HISTORIC AND DESIGN REVIEW COMMISSION

April 05, 2023

HDRC CASE NO: 2023-099
ADDRESS: 327 E KINGS HWY
LEGAL DESCRIPTION: NCB 6327 BLK 2 LOT 50
ZONING: R-5, H
CITY COUNCIL DIST.: 1
DISTRICT: Monte Vista Historic District
APPLICANT: Oscar Flores/Oscar Flores Design Studio
OWNER: JOHN MALONEY/MALONEY JOHN PATRICK JR
TYPE OF WORK: New construction
APPLICATION RECEIVED: March 10, 2023
60-DAY REVIEW: Not applicable due to City Council Emergency Orders
CASE MANAGER: Rachel Rettaliata

The applicant is requesting conceptual approval to construct one 2-story, single-family structure and one 1-story detached garage at 327 E Kings Hwy.

1 FRONT ELEVATION
SCALE: 1/4"=1'-0"

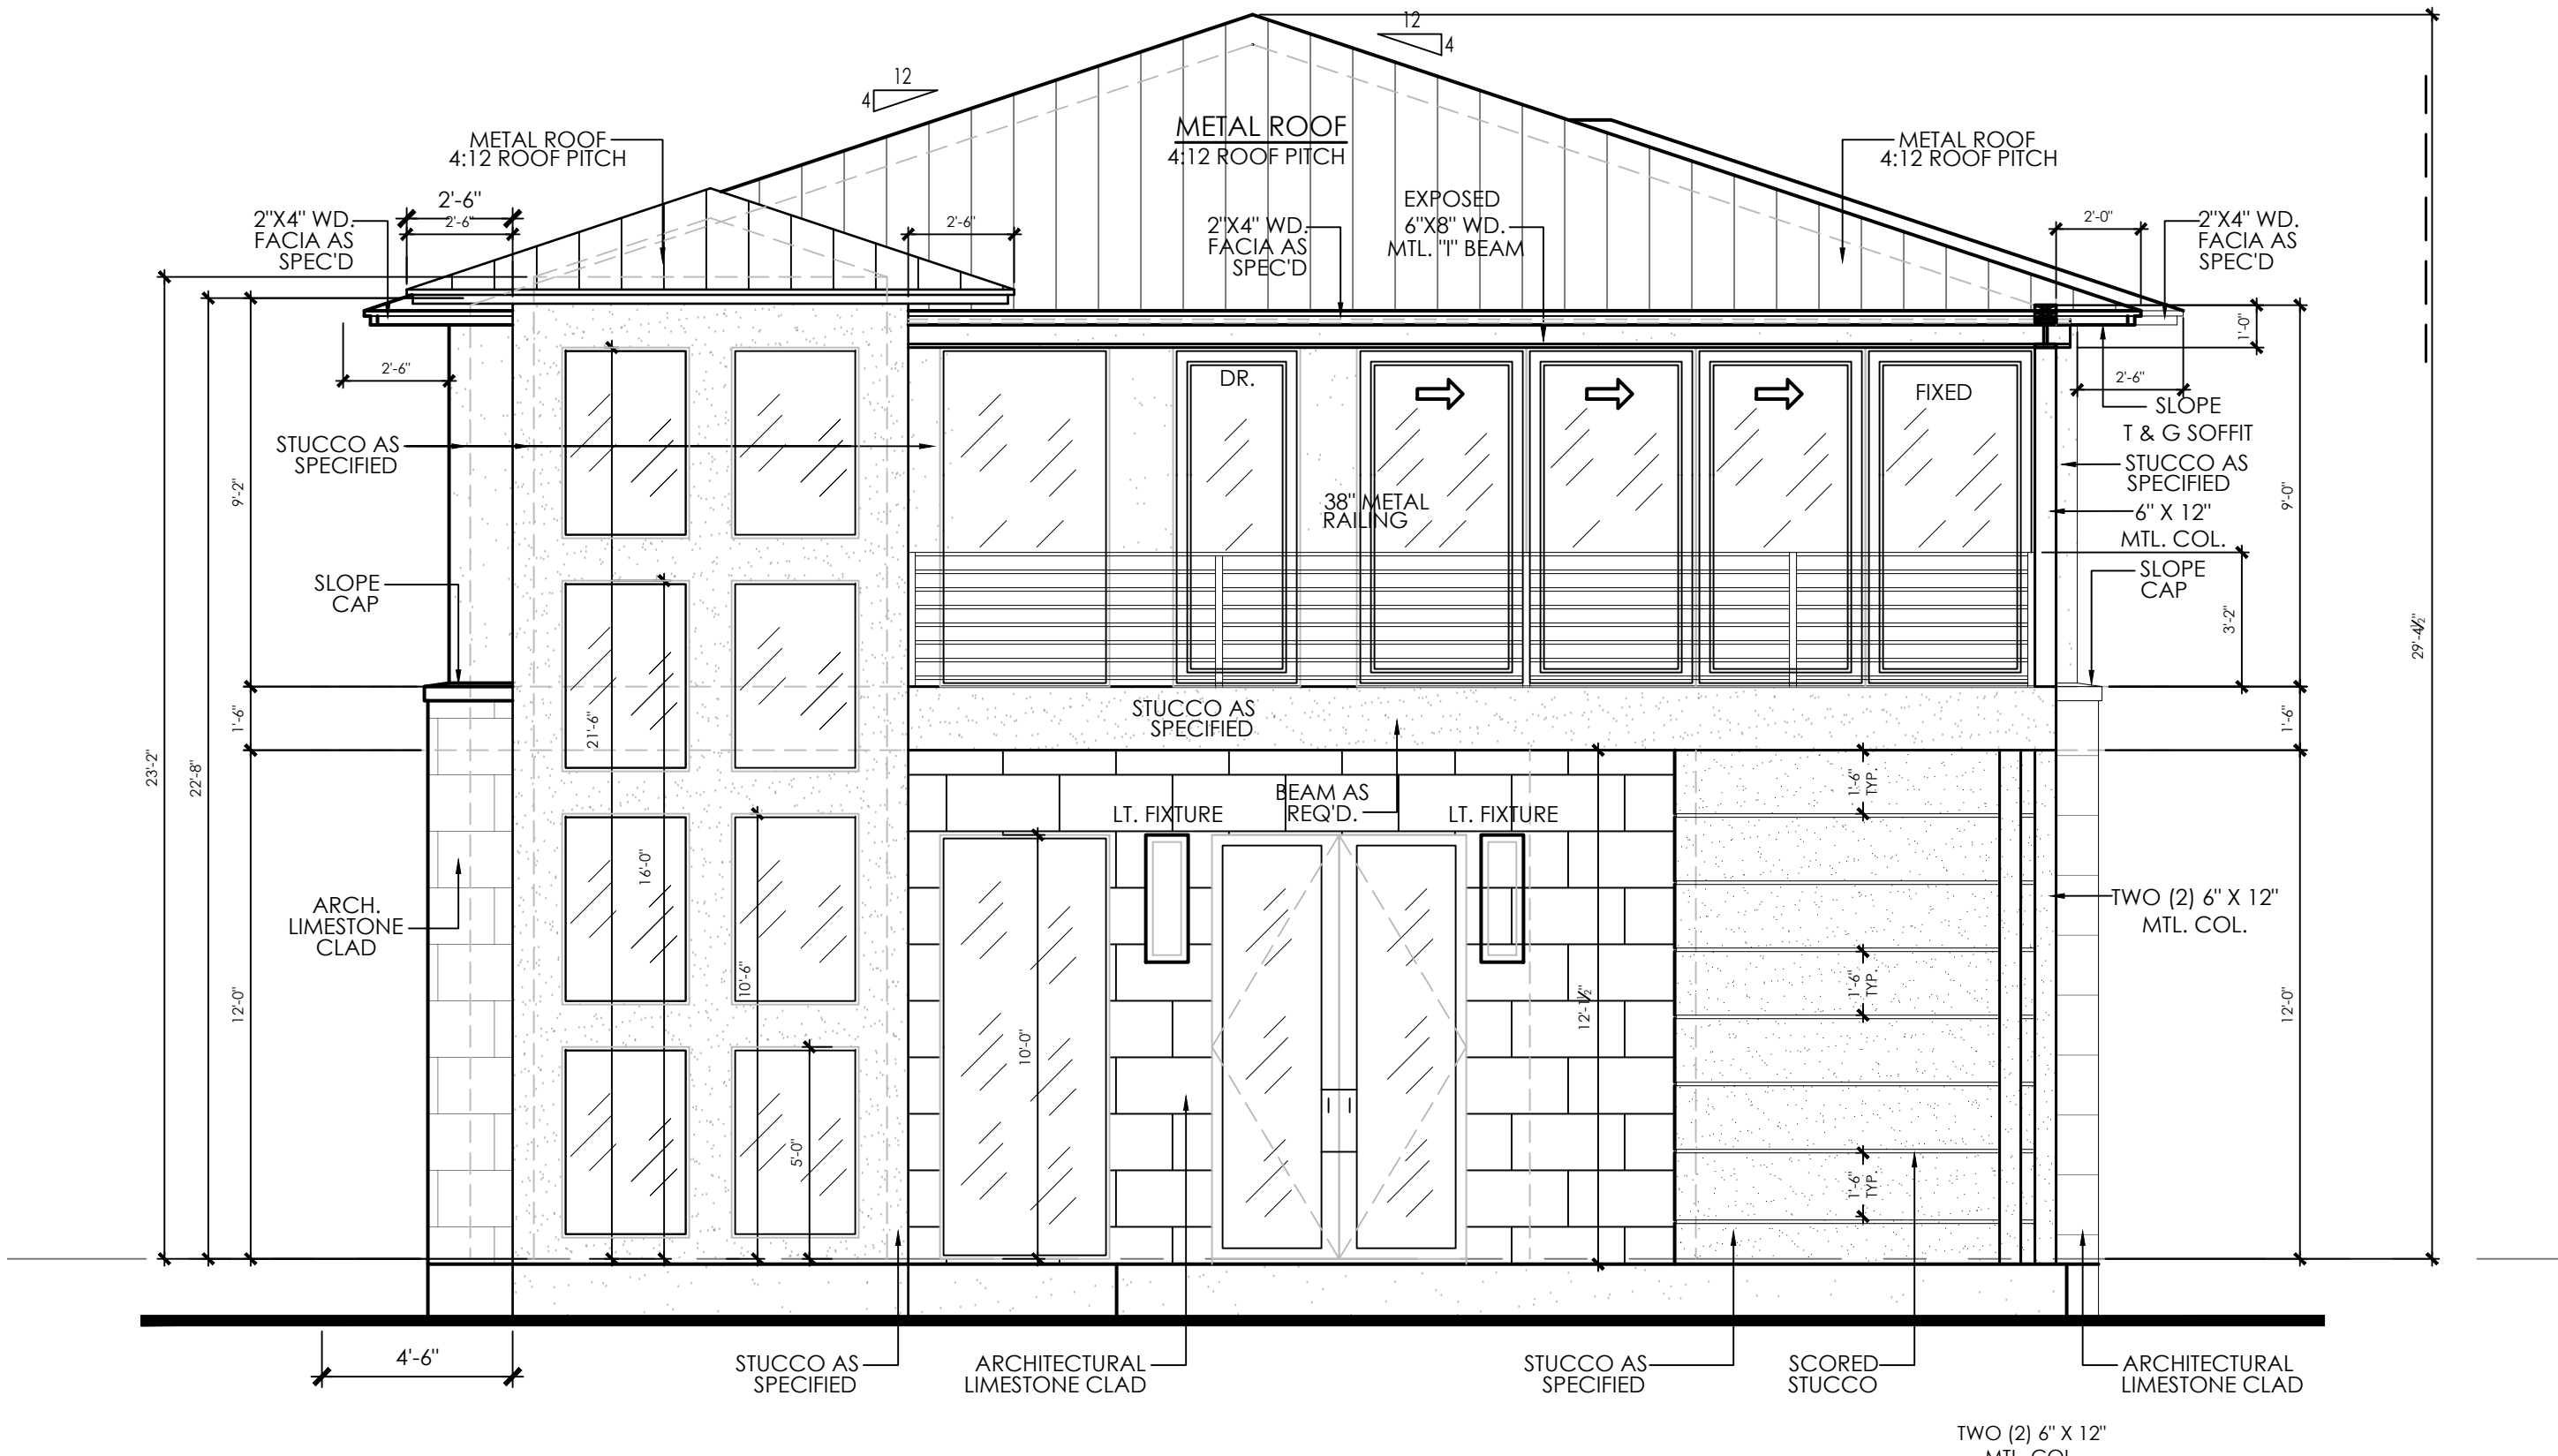
JF: I would recommend checking the Guidelines on that. I see that there is a location for a future elevator that would pop out onto the front elevation. If that is part of the long-term design, I would like to see what that volume does to the look of the front elevation. At least side-by-side elevations showing what that would be when constructed. The rendering on page 2, right side first floor is solid limestone, whereas the building drawing elevation shows windows there. So we would like to know if you are proposing windows there or not.

SHEET TITLE
RIGHT & LEFT SIDE
ELEVATIONS

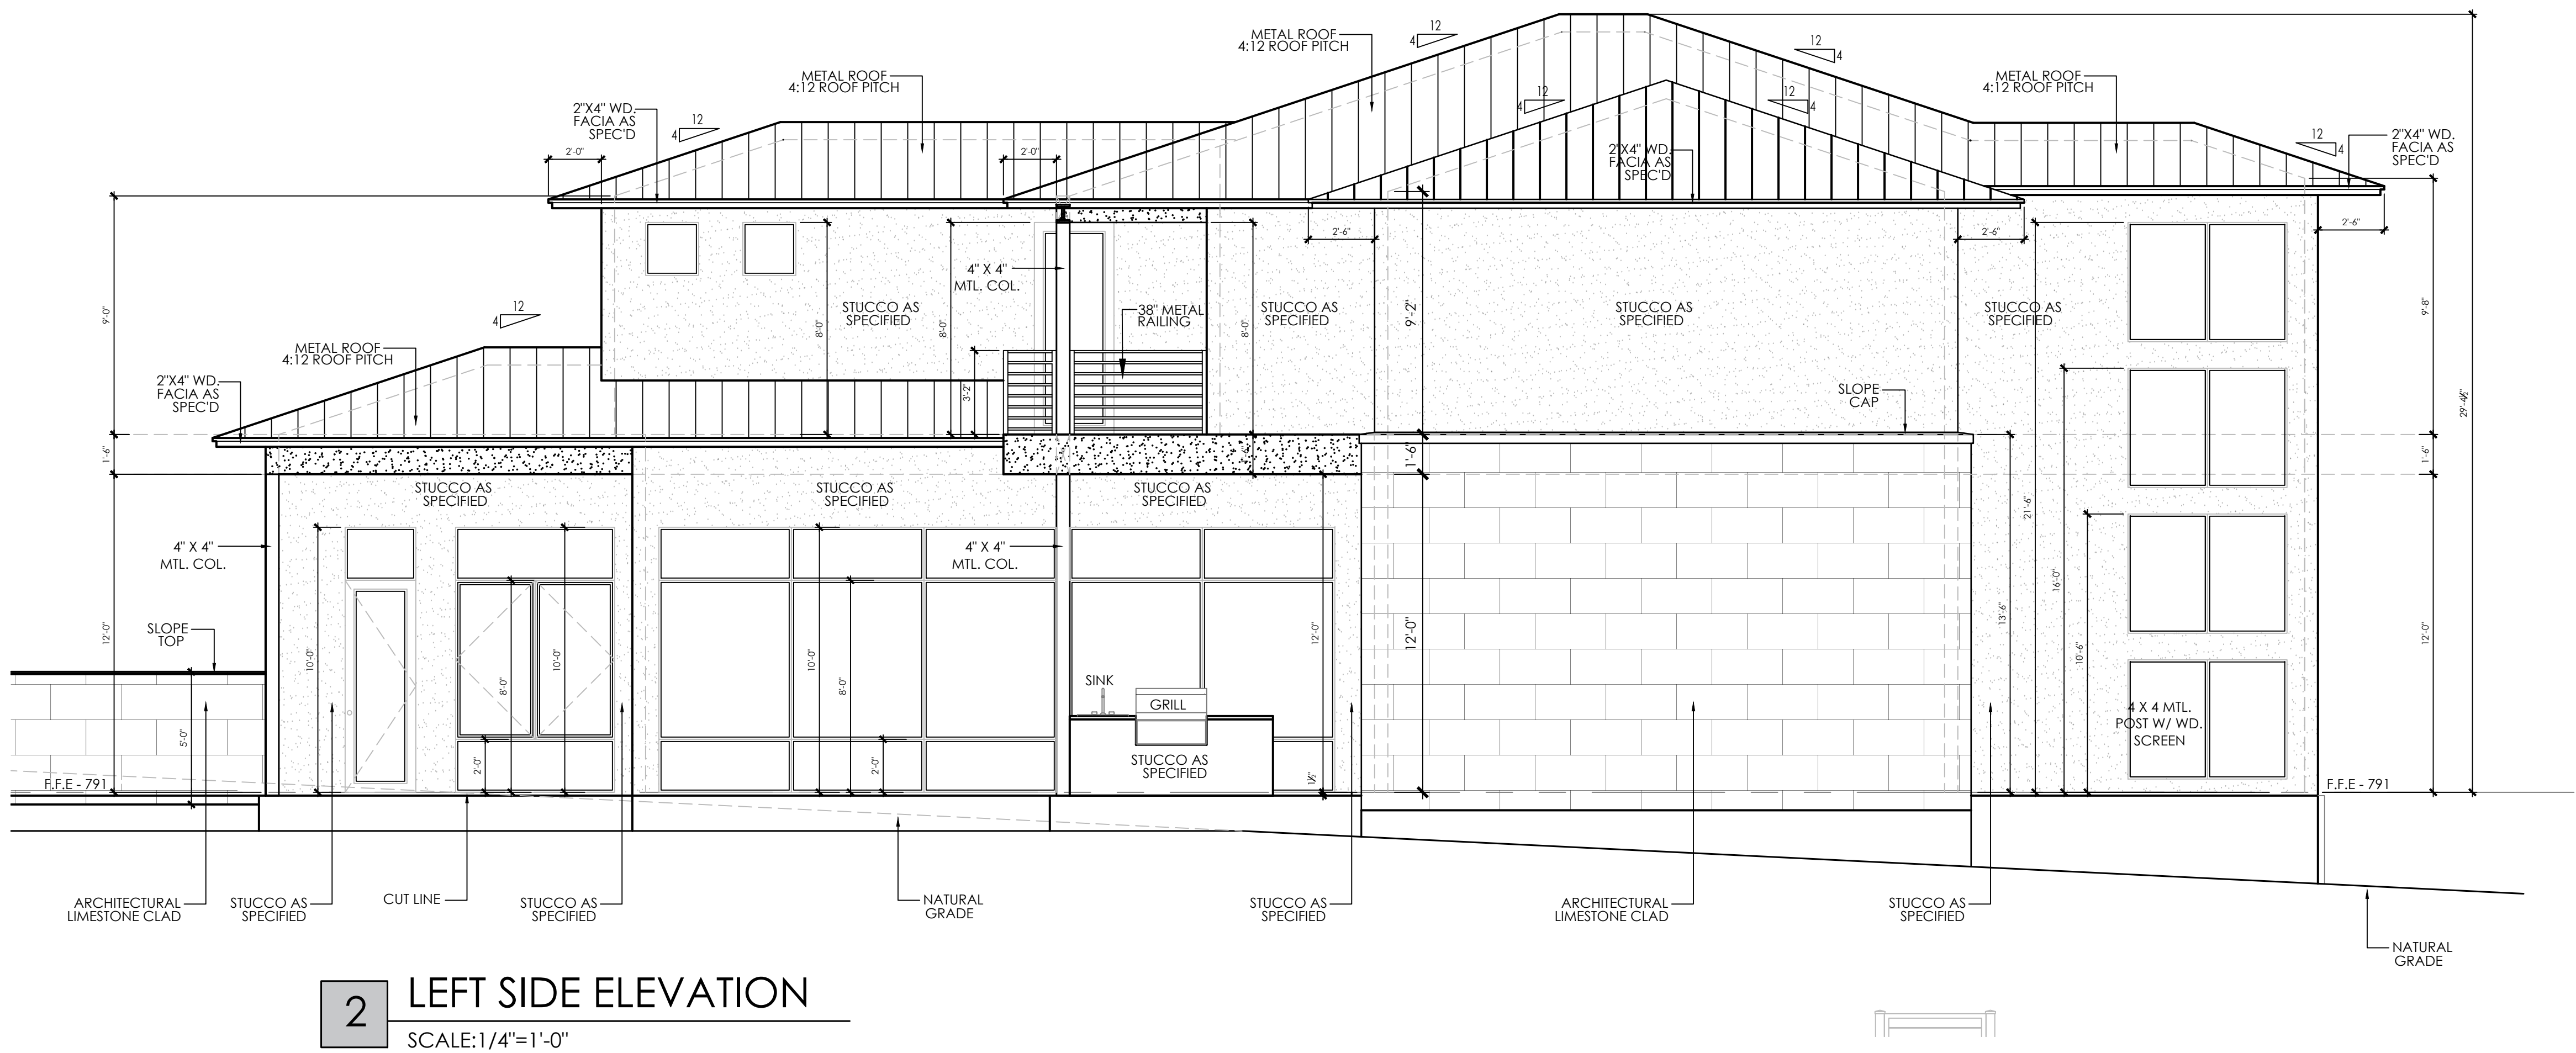
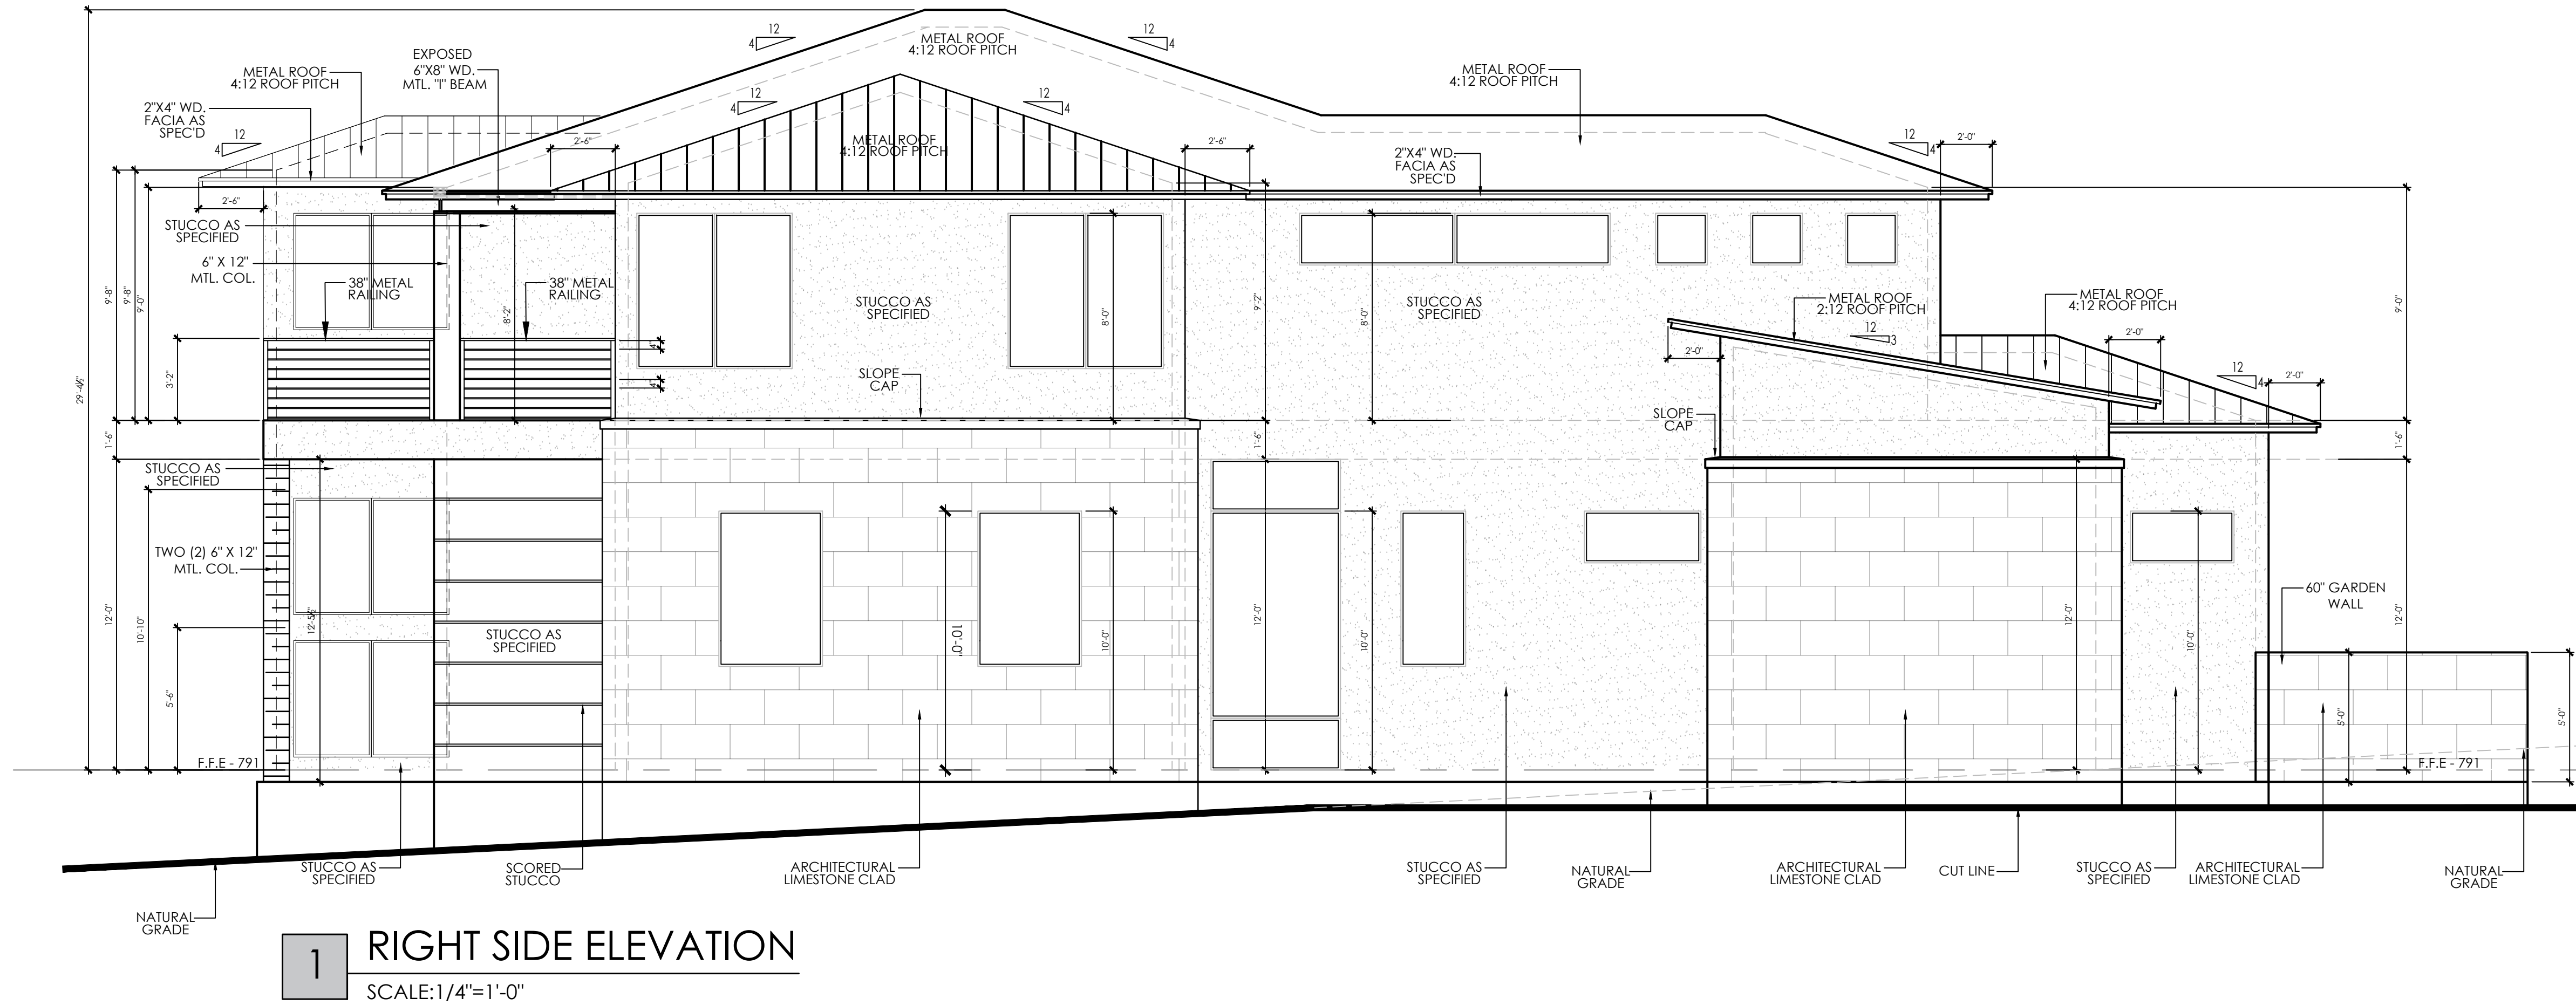
JF: In terms of fenestration, there is a large 2-story volume without fenestration on the left side elevation and from your floor plan it looks like you can incorporate some windows there. The smaller scale windows on the right side elevations, the square ones up high, are more appropriate than the long horizontal windows. I would recommend incorporating the smaller square windows.
